## Global MX-5 Cup Technical Service Bulletin #2-25-16

## **Front Brake Line Mounting**

**Figure 1**. Brake Line Mounted on Bottom of Control Arm. ←**Incorrect** brake hose mounting

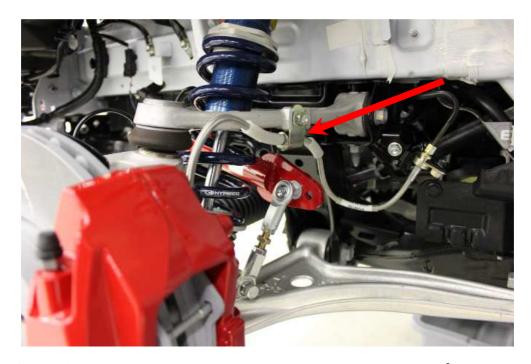
Some front brake lines may have been mounted on the bottom side of the control arm as shown in figure 1. Please take a moment to check *both* front brake line routings and then refer to the drawings below:

The brake line routing should be mounted on the <u>top side</u> of the control arm as shown in figure 2. If your front brake lines are mounted as shown in figure 1 (on the bottom of the upper control arm), please remove the retaining bolt, rotate the brake line locating bracket as shown in figure two. Then place a small amount of blue Loctite on the bolt, replace it into the upper control arm and torque the bolt to 13.8 - 18.8 ft pounds

**Figure 2**. Brake Line Mounted on Top of Control Arm. ← **Proper** brake hose mounting
